AK
	Application No.	Applicant(s)	
	10/692,376	TAMIYA ET AL.	
Notice of Allowability	Examiner	Art Unit	
	Marissa J. Detschel	2877	
The MAILING DATE of this communication appeal claims being allowable, PROSECUTION ON THE MERITS IS herewith (or previously mailed), a Notice of Allowance (PTOL-85) NOTICE OF ALLOWABILITY IS NOT A GRANT OF PATENT R of the Office or upon petition by the applicant. See 37 CFR 1.313	(OR REMAINS) CLOSED in a or other appropriate community. This application is su	this application. If not included nication will be mailed in due c	d ourse. THIS

EXAMINER'S AMENDMENT

FIG. 1 PRIOR ART

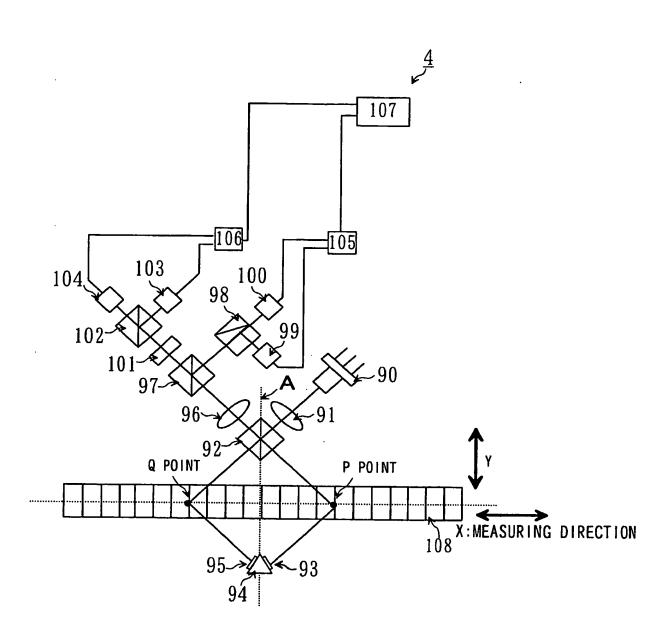
- In regards to Figure 1, a label for -- Prior Art-- has been added.
- In regards to Figure 2, the label "Q POING" has been replaced with -- Q POINT-
- In regards to claim 2, line 2, the phrase "on one of ends" has been replaced with --on one end--.
- In regards to claim 4, line 2, the phrase "in stack perpendicularly" has been replaced with --in a stack perpendicular--.
- In regards to claim 15, line 4, the phrase "in stack perpendicularly" has been replaced with --in a stack perpendicular--.
- In regards to claim 18, line 4, the phrase "in stack perpendicularly" has been replaced with --in a stack perpendicular--.
- In regards to claim 20, line 1, the phrase "first and light sources" has been replaced with --first and second light sources--.
